NARRAGANSETT BAY COMMISSION

PHASE III COMBINED SEWER OVERFLOW PROGRAM
OF-210/213/214 FACILITIES

CONTRACT NO. 308.04C

60% DESIGN
JULY 2021

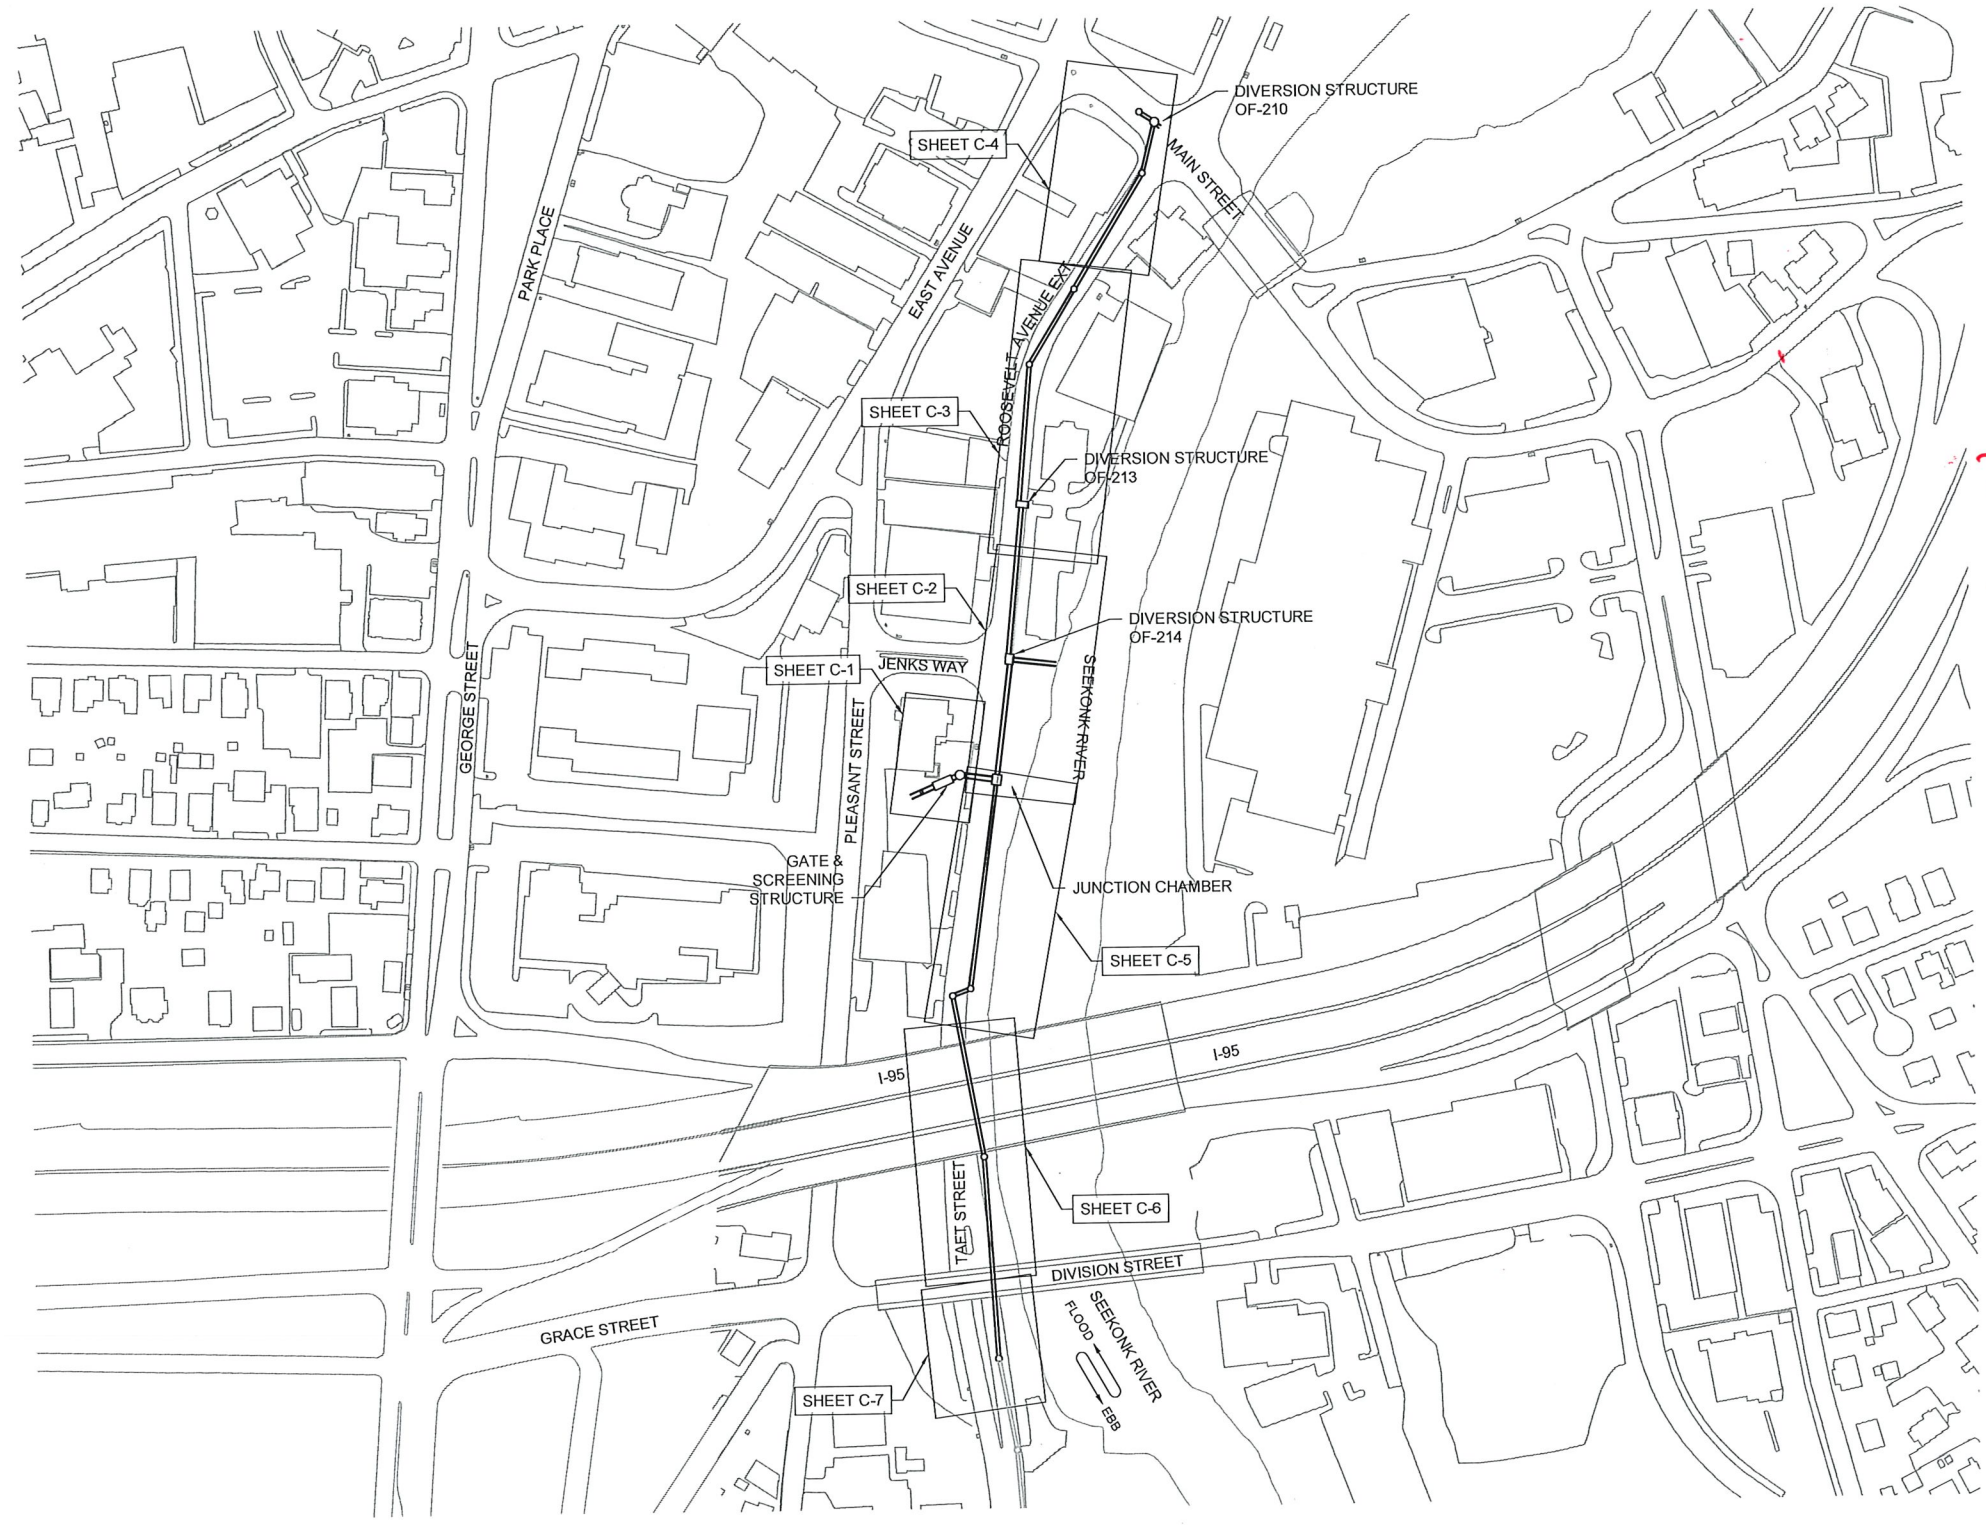
*Where are drawings for
control bldg?*

LOCATION MAP

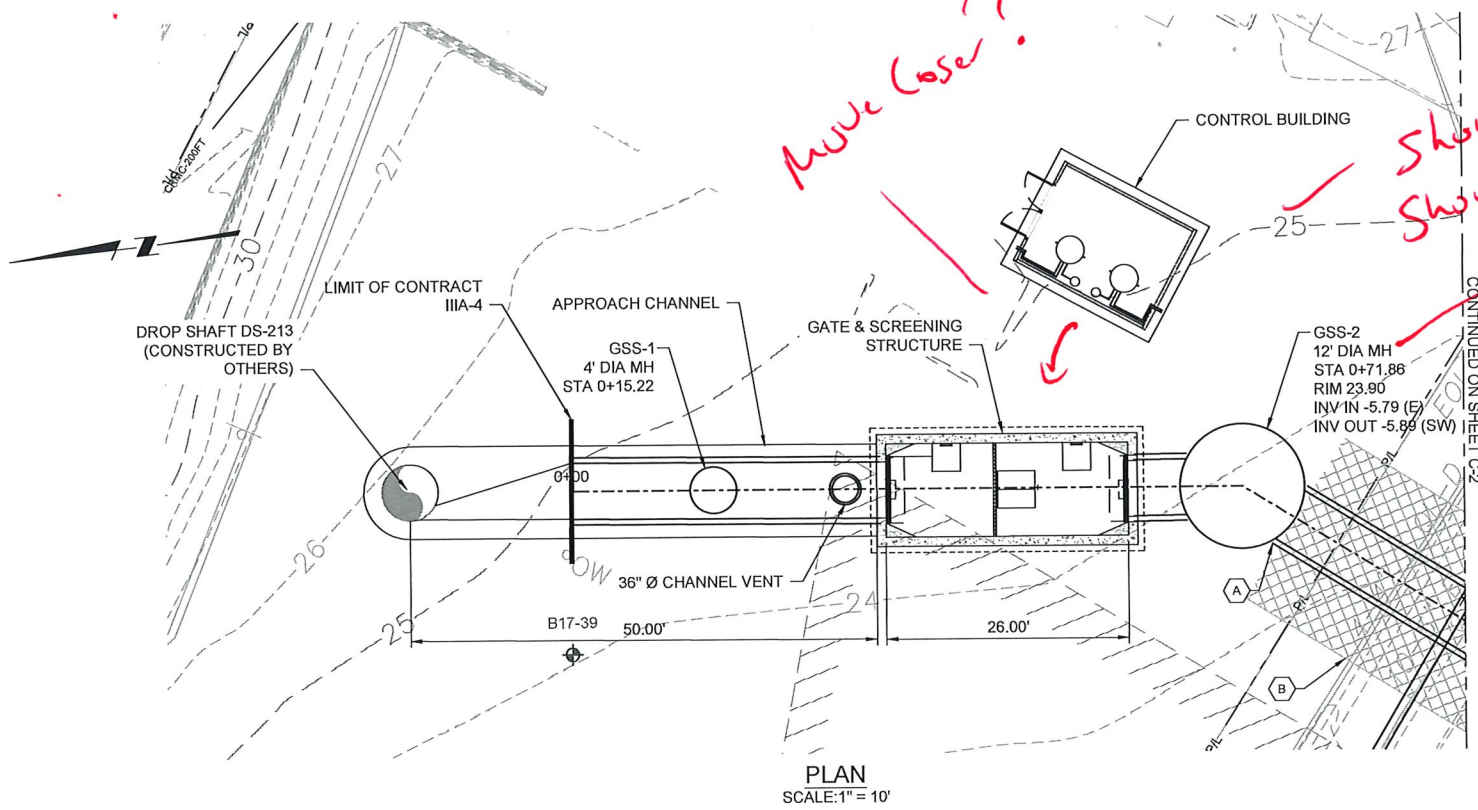
It is NOT necessary to incorporate comment for RIDEEM submission. Prior to bid set, incorporate paving limits to complete final pour for both IIIA-A & IIIA-S project limits. Paving limits can be adjusted following construction of IIIA-S.

SHEET
 C-1
 195130227

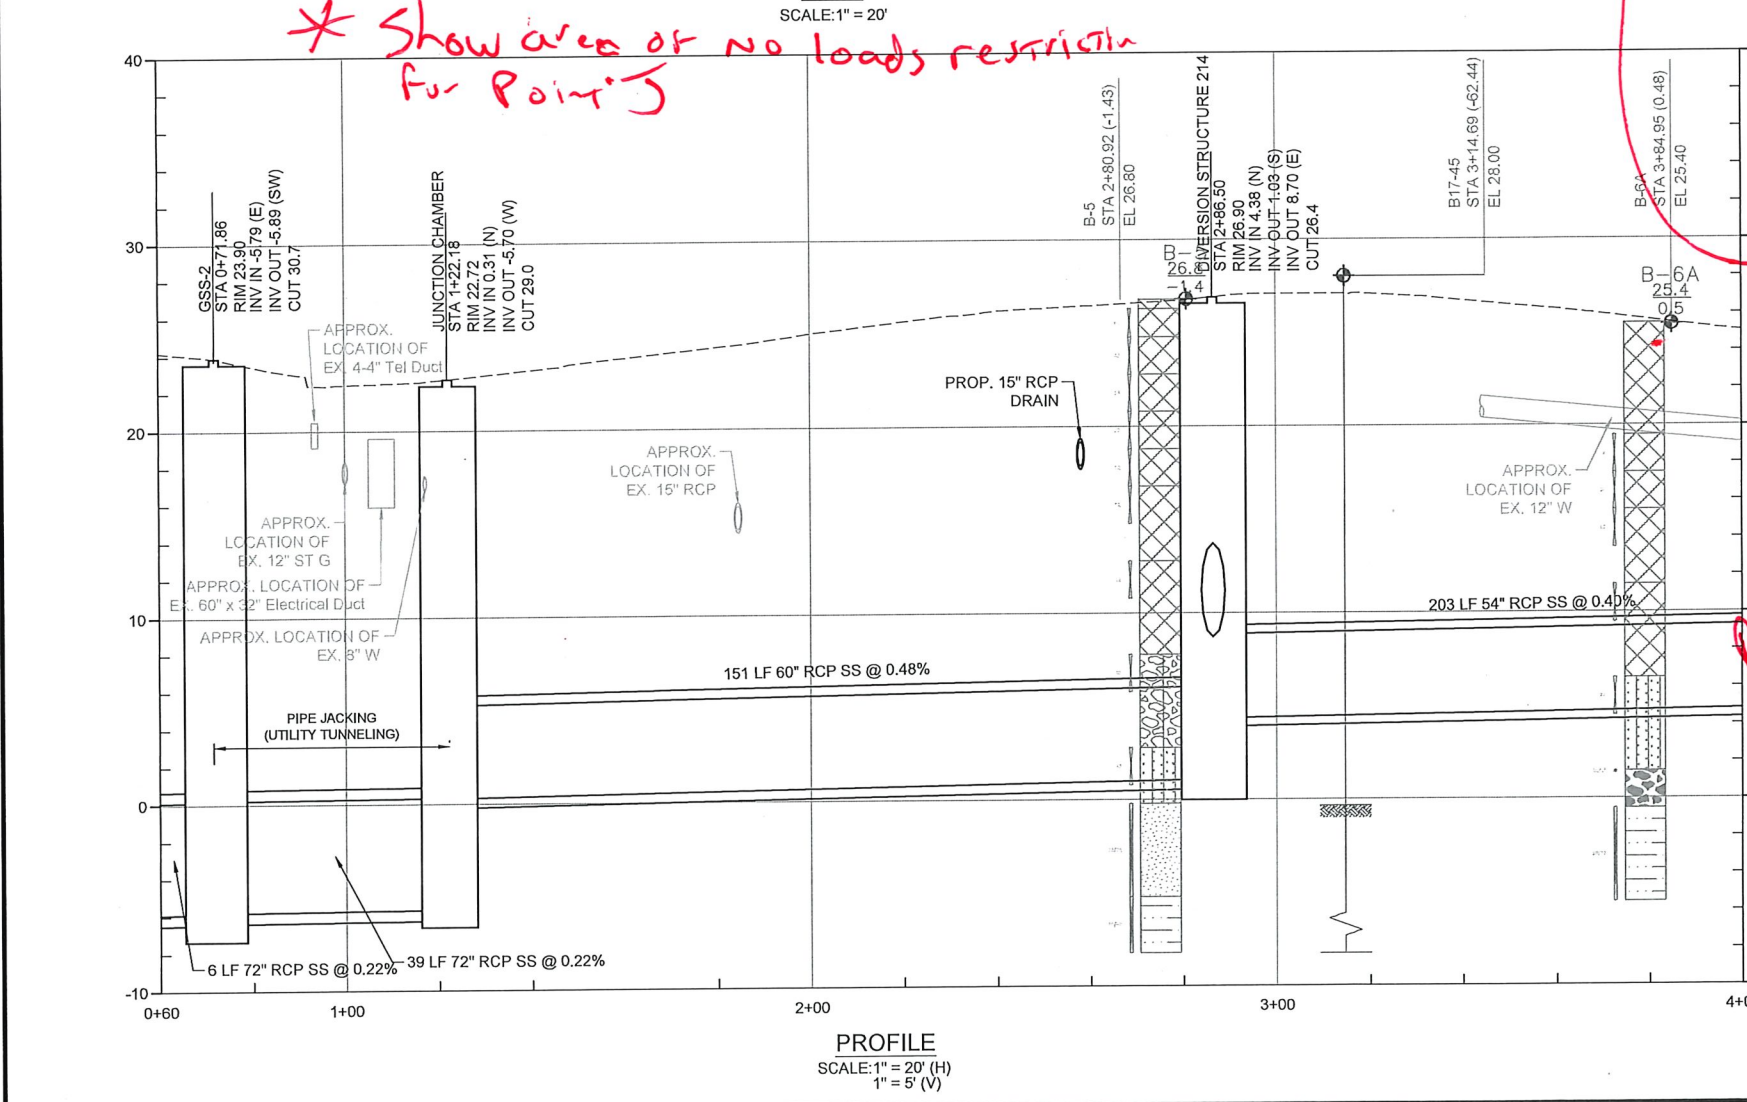
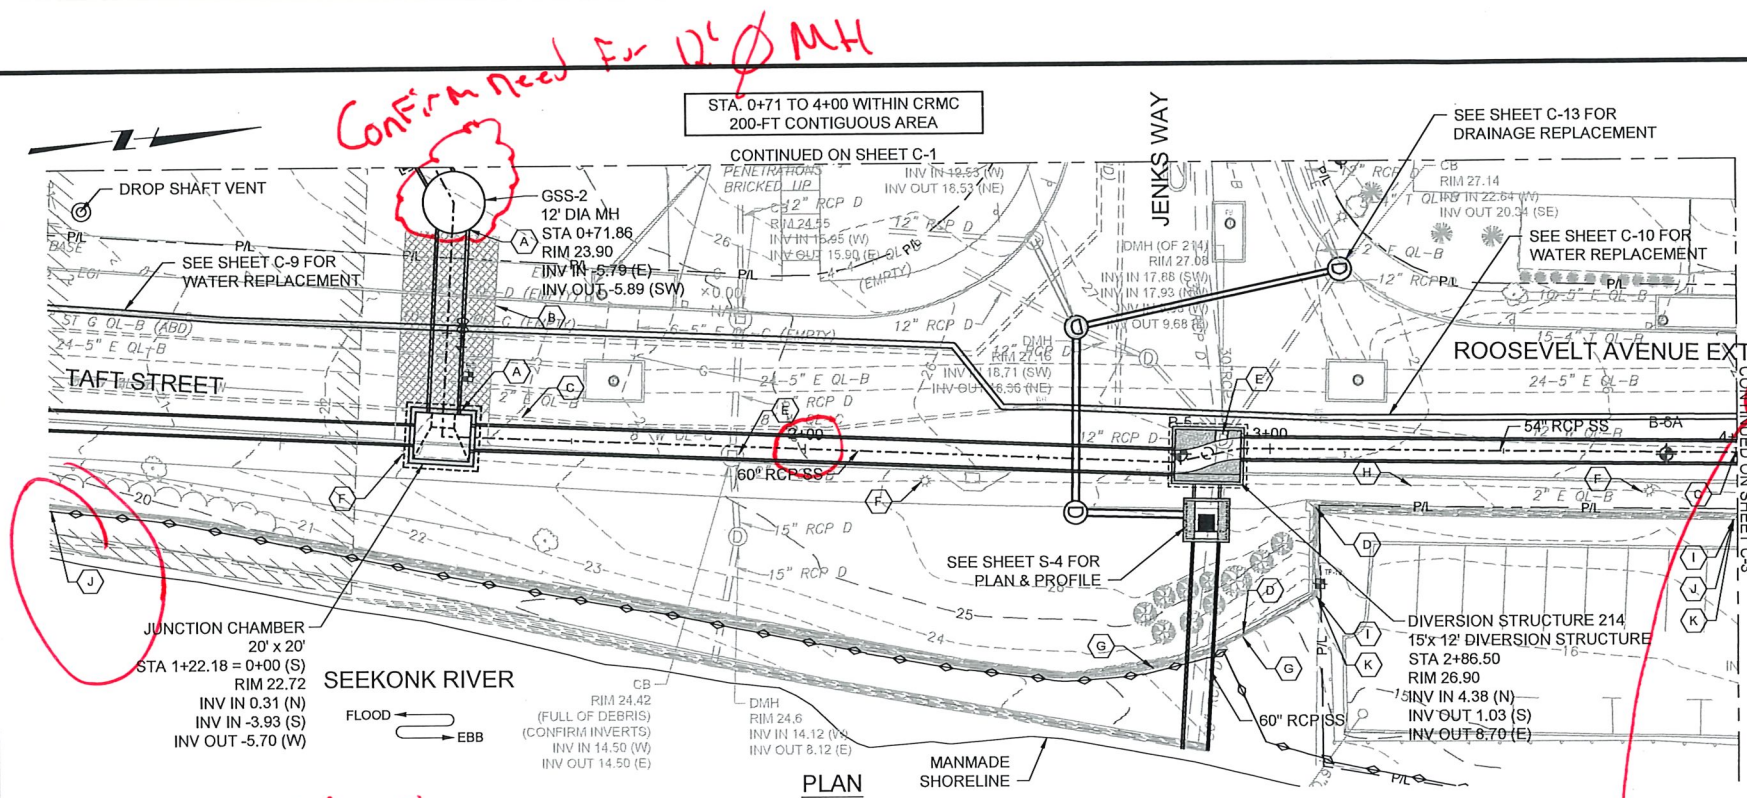
- SHEET KEYNOTES
- A. PIPE JACKING: STATION 0+72 TO STATION 1+22
 - B. AREA TO RECEIVE GROUND IMPROVEMENT - CHEMICAL INJECTION
- Chemical vs. jet grout benefits?

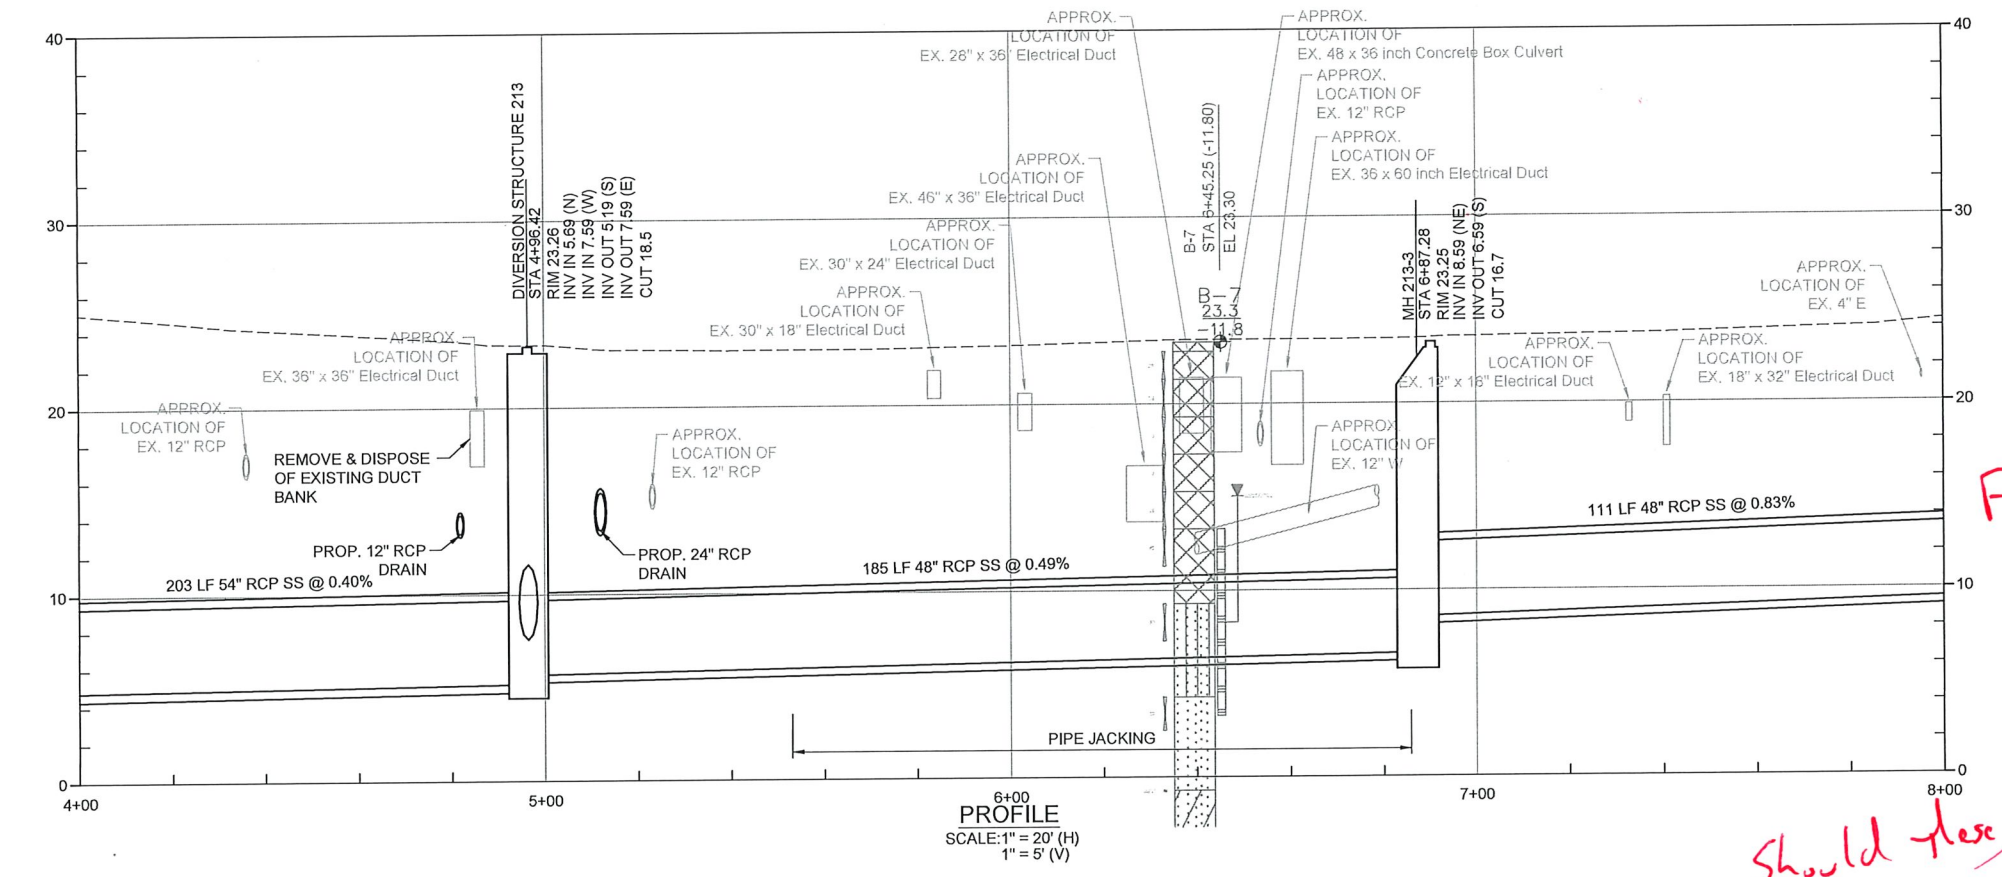
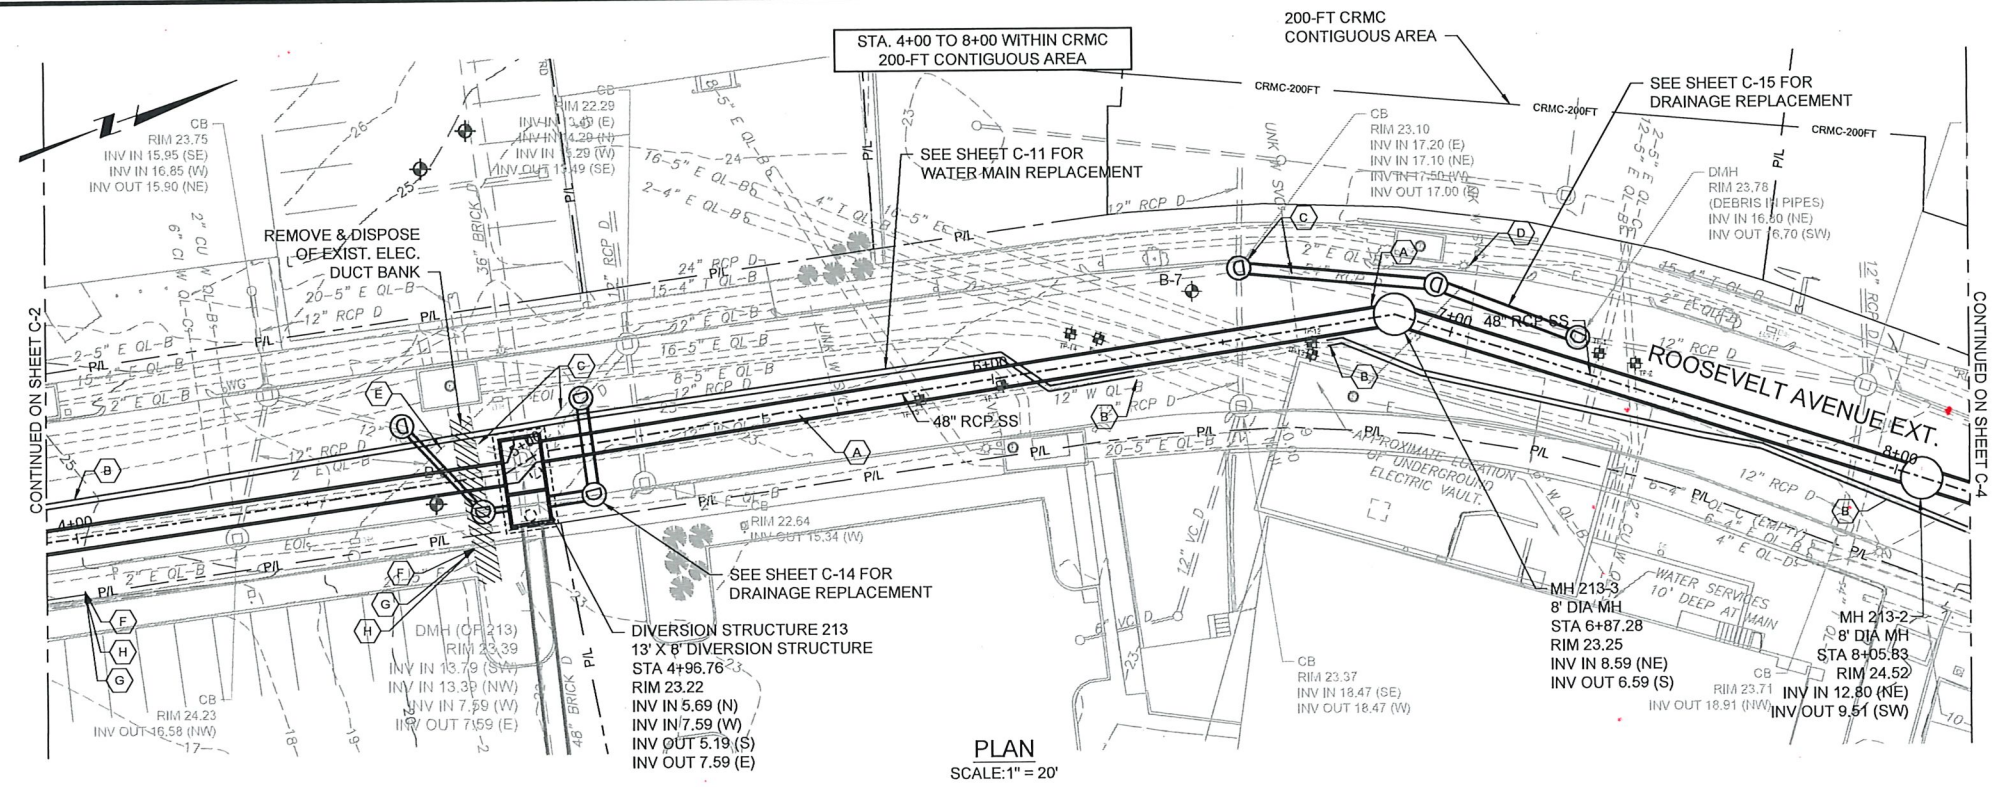
** Show area of no loads restriction for Point J*

Stationing hard to see in plan view.

Why leave this to contractor? What information do you provide for bidders?

Show limits of grouting in plan view along wall.

this is a privately owned wall. Will repointing provide a benefit? Should focus be on instrumentation former?
